RE: Southeast County Landfill Permit Renewal - Responses to Additional Information Request

Subject: Response to the Florida Department of Environmental Protection's letter dated December 15, 1994, regarding the Operation Permit Renewal for the Southeast County Landfill, Hillsborough County, Florida, Pending Permit No. S029-256427

EXHIBIT B
PIEZOPROBE PP-6 GRAPH

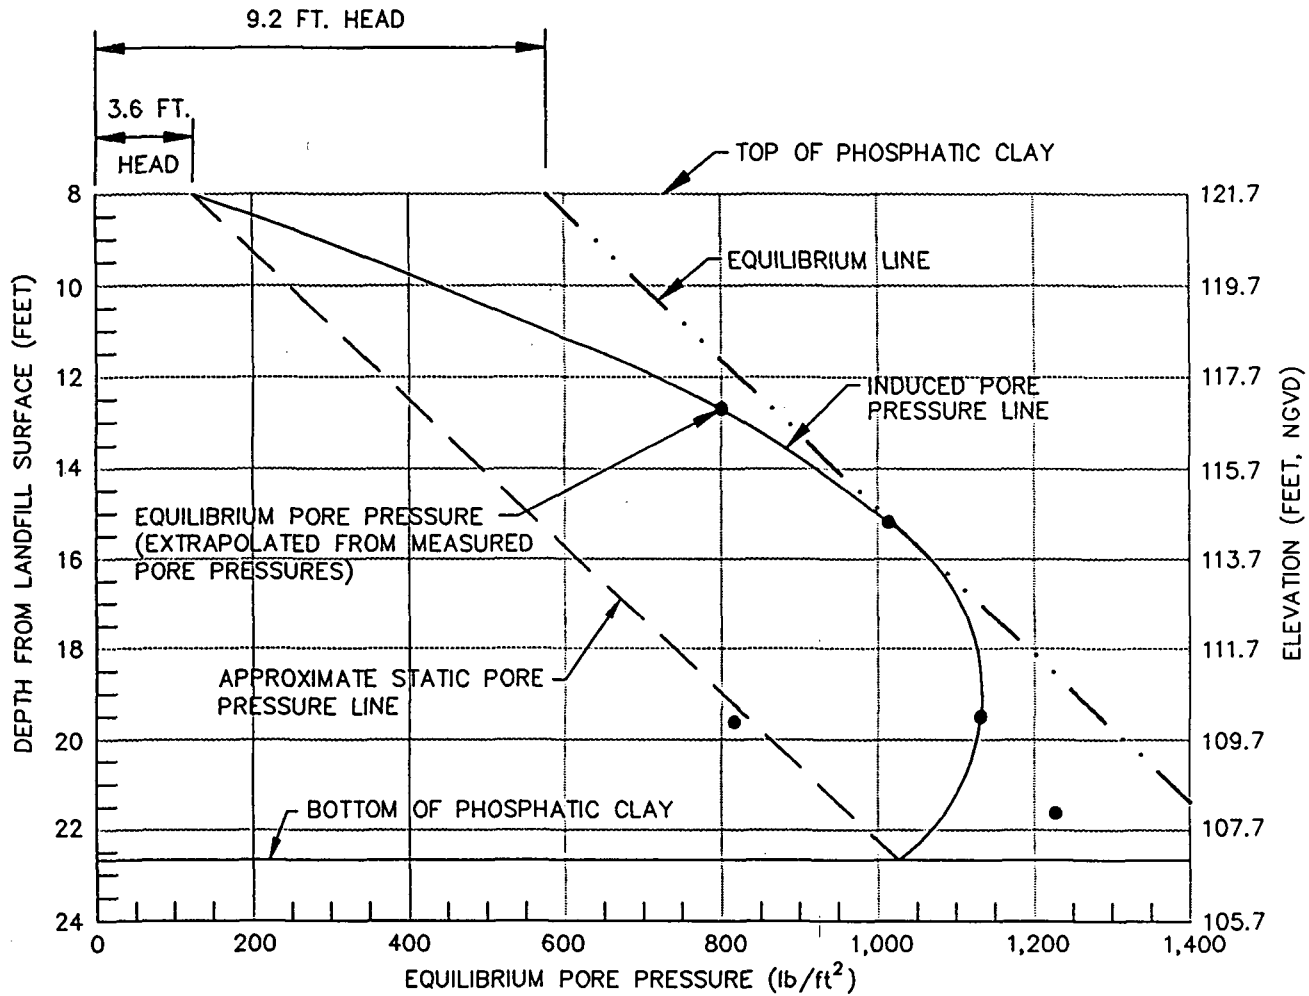
5. **FDEP Statement 5** - SCS states that Ardaman's boring PP-2 was at the worst case location because it had been 6.7 years since that area was last filled. At the time of Ardaman's investigation, how long had it been since Phase I was last filled? Did Ardaman test the worst case location?

We should have used the term "best case" scenario for calculating leachate levels that would induce a hydraulic head of 12 inches or less (i.e., 12 inches for year 7 and less for any year prior to the seventh). For example, piezoprobe PP-6 in Phase VI indicates that after 1.3 year preloading period, it would require 9 feet of liquid head to reach hydraulic equilibrium (see Exhibit B).

Response - Ardaman performed test PC-1 in Phase I; however, the lapsed time in Phase I is over 8 years. According to current projections, the time interval between successive lifts should not exceed 7 years again. In addition, 7 years is the interval at which 95 percent consolidation is expected; therefore, SCS believes that PP-2 in Phase II is a closer representation of the sequence conditions planned for the Southeast Landfill (SELF).
